SUBJ: **Addendum 1 – Clarifications to the Specifications and Responses to Vendor's Questions**

BID ITEM: **Bid Item #23-150 Construction - Airfield Electrical System Upgrade for Runways 5-23 & 11-29 for Augusta, GA – Daniel Field Airport**

ADDENDUM NO. 1

AIRFIELD LIGHTING DEMOLITION PLAN
RUNWAY 5/23 - PART 5
ED5
 Sheet 17 of 52

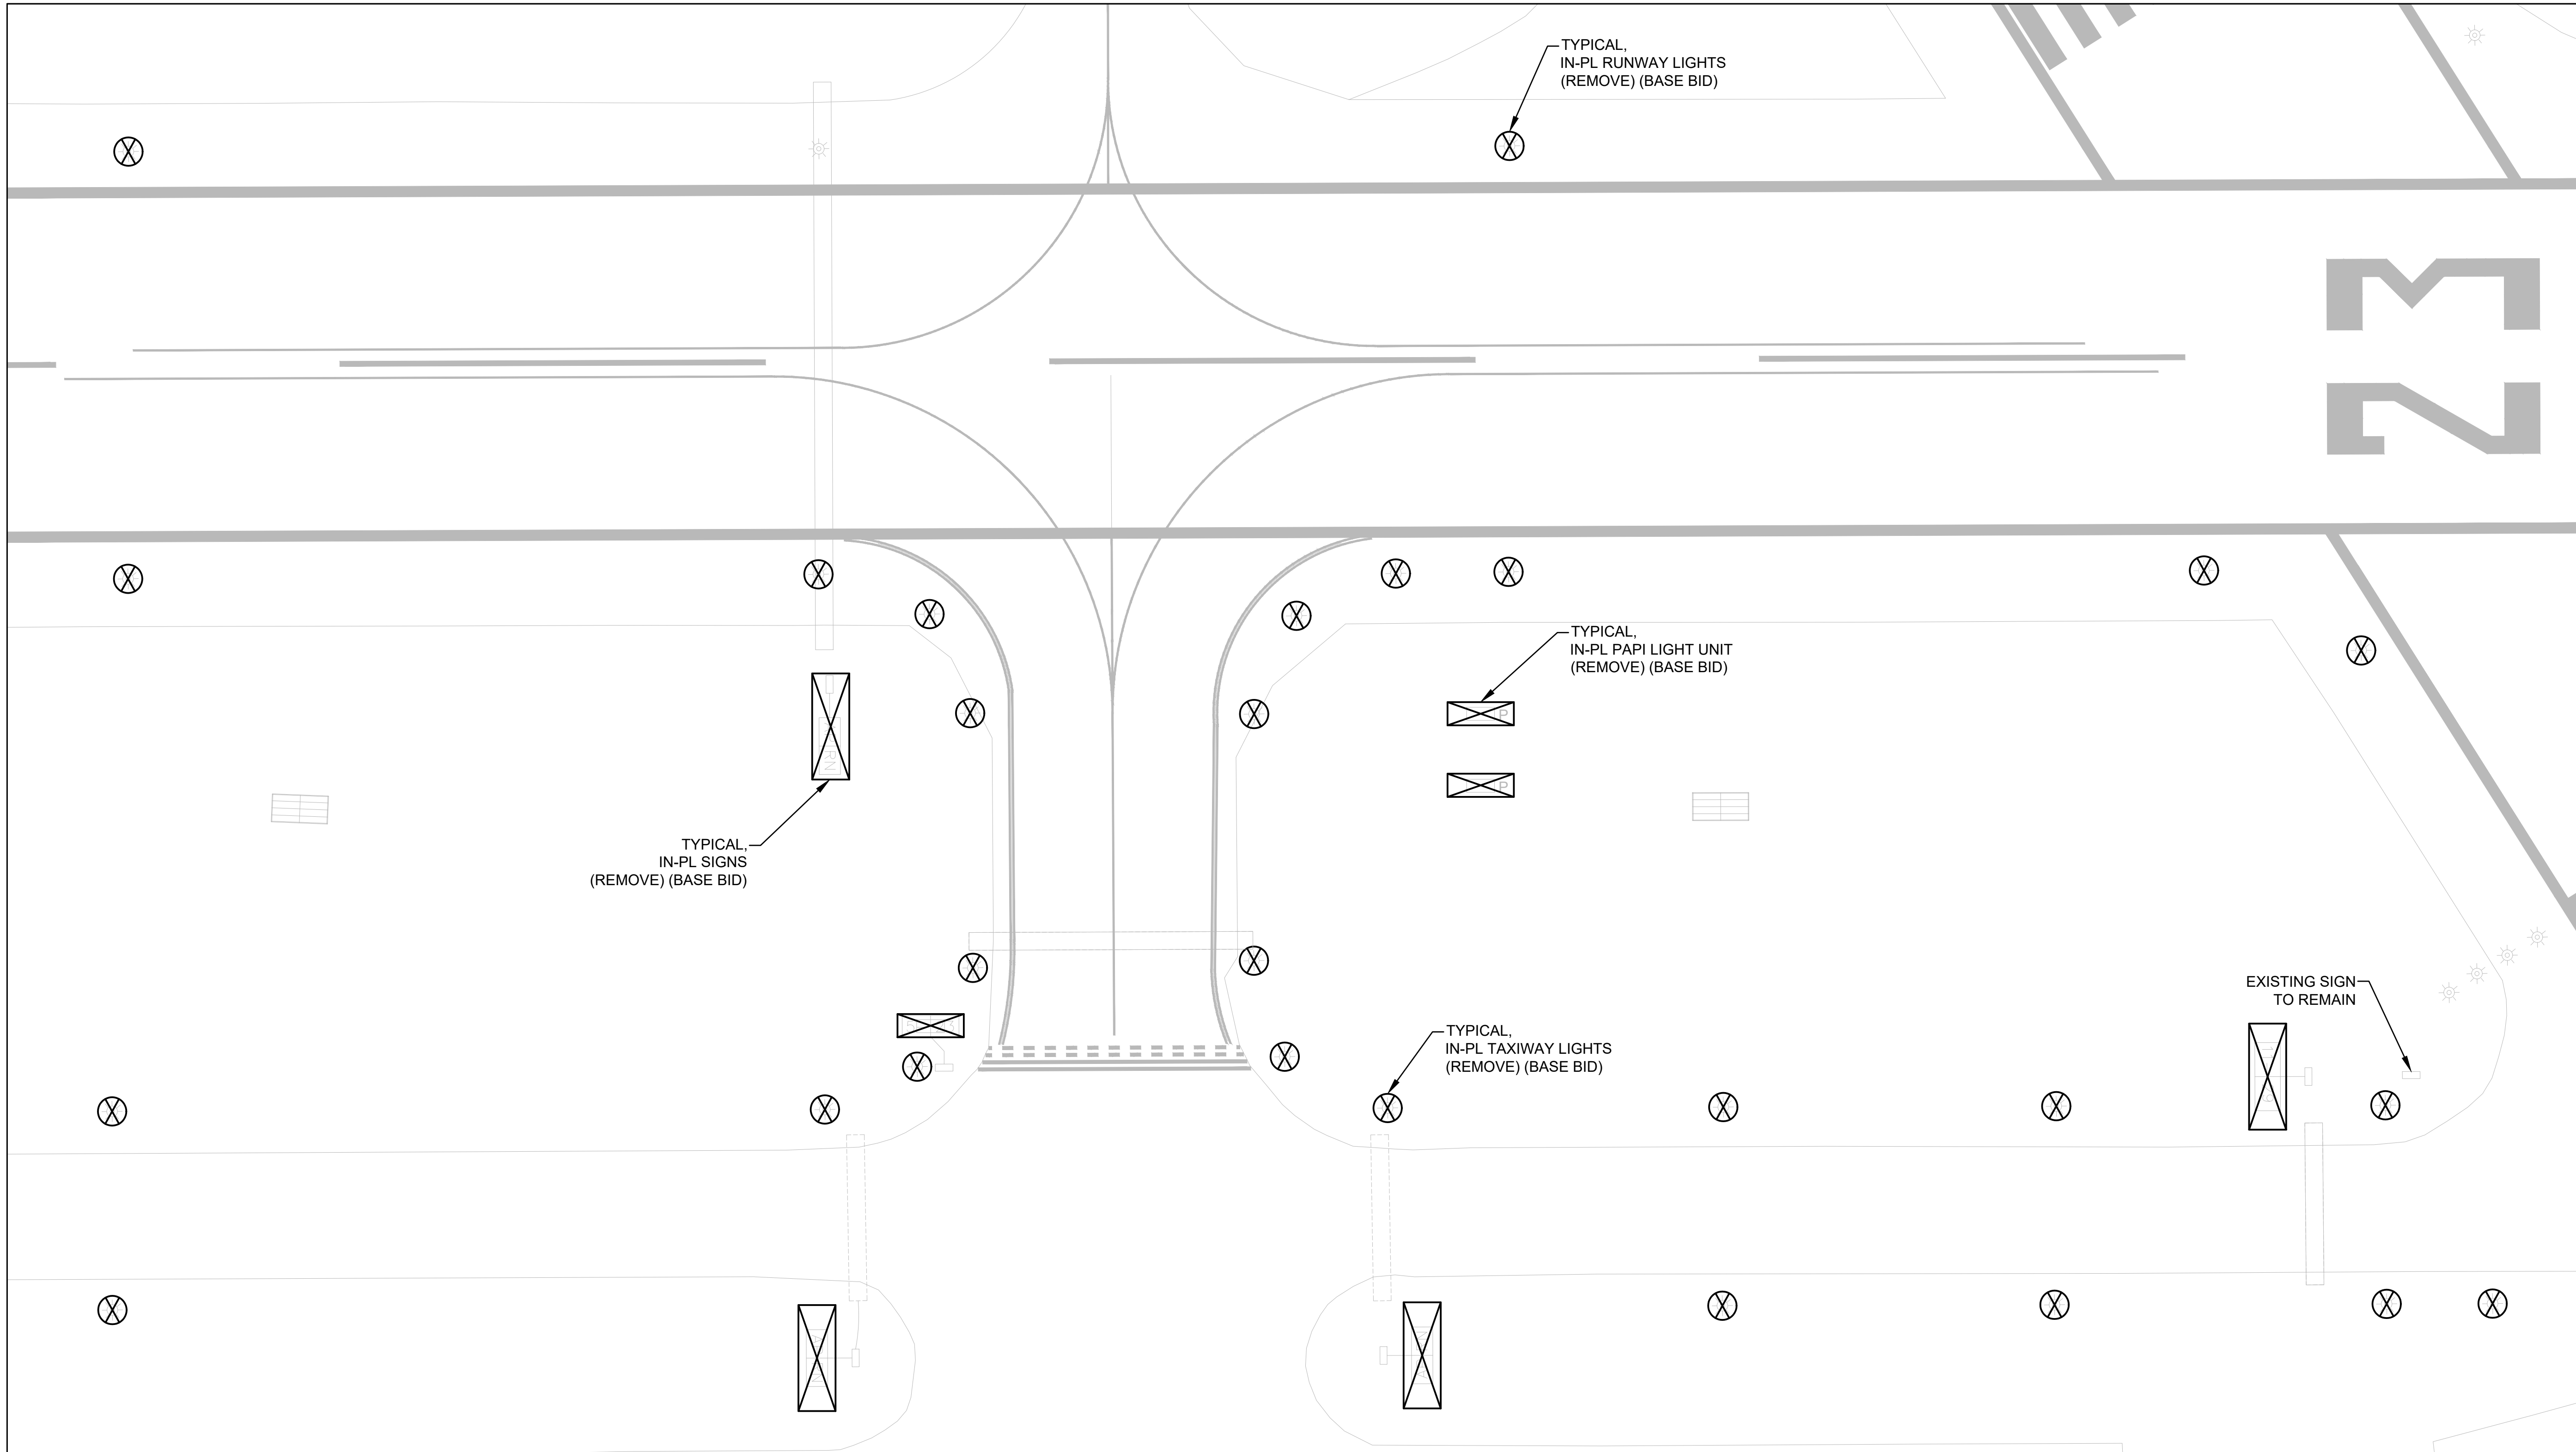
- Scale of this sheet revised from 1"-50' to 1"-25'.
- H. **Replace Sheets ED5** – Airfield Lighting Demolition Plan – Runway 5/23 – Part 5 with revised Sheets ED5 attached to this Addendum 1.

- Scale of this sheet revised from 1"-50' to 1"-25'.
 - Mandatory sign 5-23 (S14) revised from being replaced to existing to remain.
- I. **Replace Sheet ED6** – Airfield Lighting Demolition Plan – Runway 5/23 – Part 6 with revised Sheet ED6 attached to this Addendum 1.

ED6
 Sheet 18 of 52

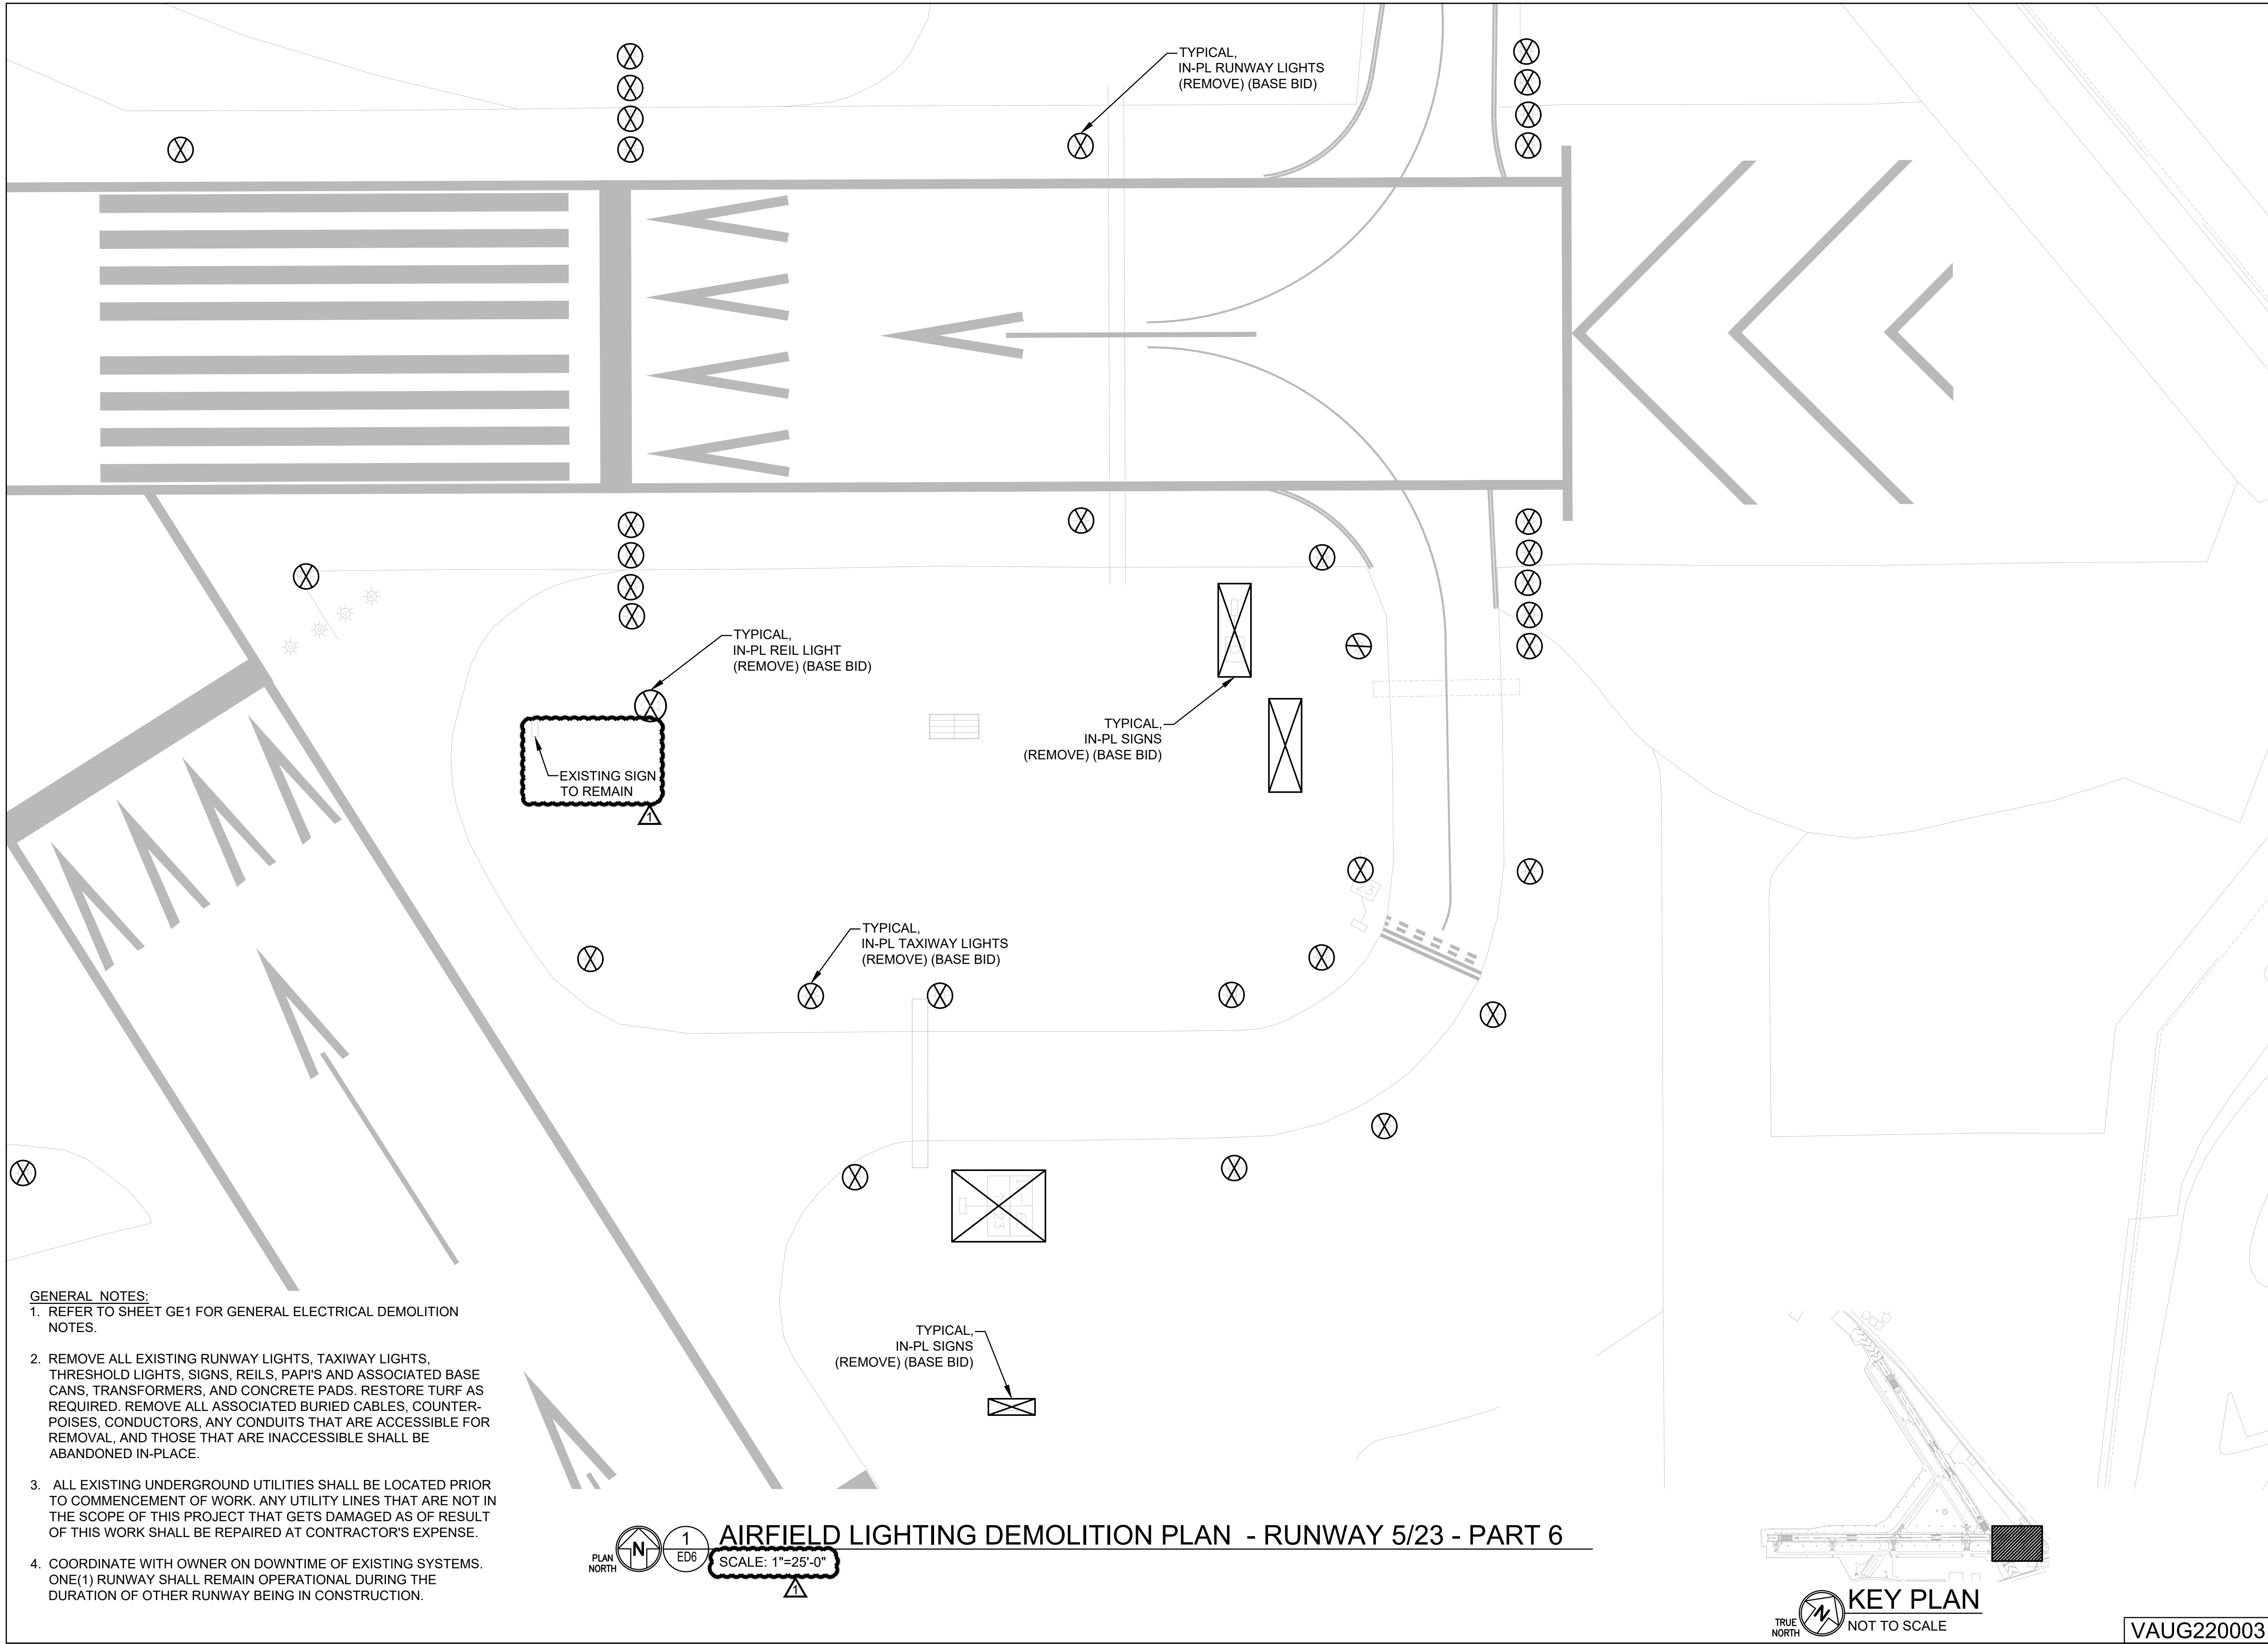
- Scale of this sheet revised from 1"-50' to 1"-25'.
 - Mandatory sign 29-11 (S16) revised from being replaced to existing to remain.
- J. **Replace Sheets ED8 - ED11** – Airfield Lighting Demolition Plan – Runway 11/29 – Part 1-4 with revised Sheets ED8 - ED11 attached to this Addendum 1.

ED12
Sheet 24 of 52

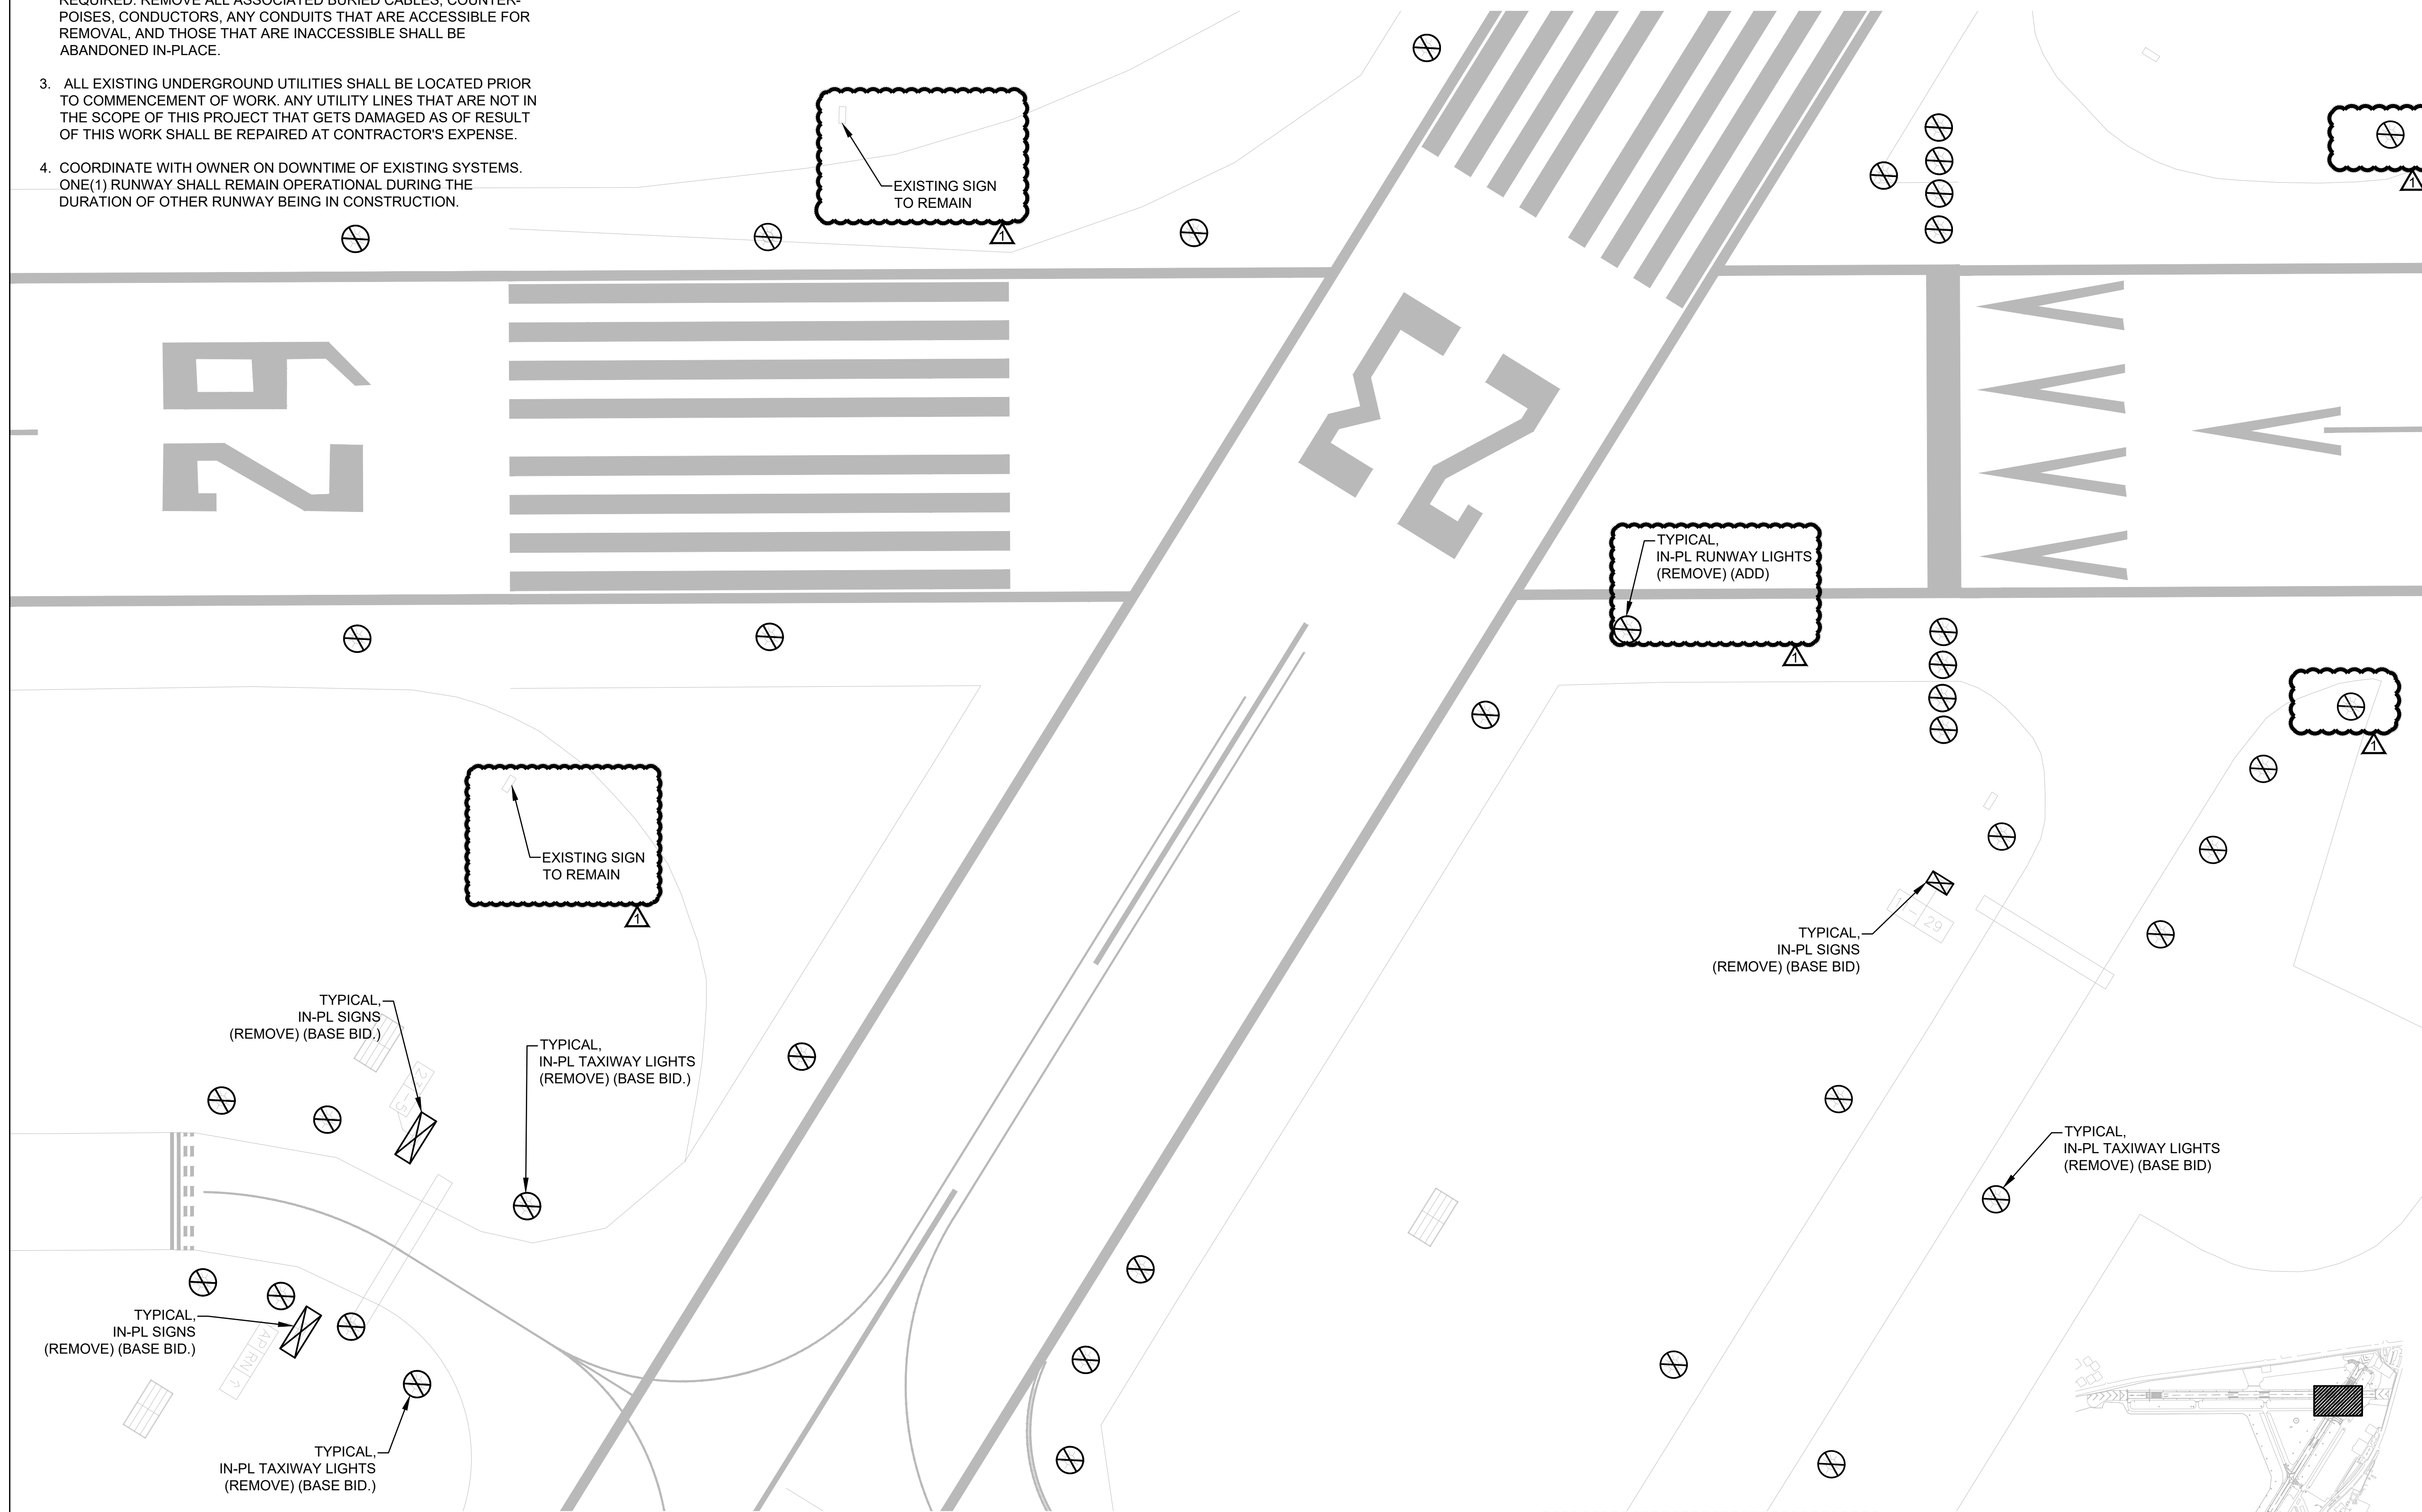
- Scale of this sheet revised from 1"-50' to 1"-25'.
 - ALT (Alternate) abbreviation and wording revised to ADD (Additive Bid).
- K. **Replace Sheet ED12** – Airfield Lighting Demolition Plan – Runway 11/29 – Part 5 with revised Sheet ED12 attached to this Addendum 1.

- Scale of this sheet revised from 1"-50' to 1"-25'.

- ALT (Alternate) abbreviation and wording revised to ADD (Additive Bid).
 - Mandatory Signs 11-29 & 23-5 (S21 & S22) revised from being replaced to existing to remain.
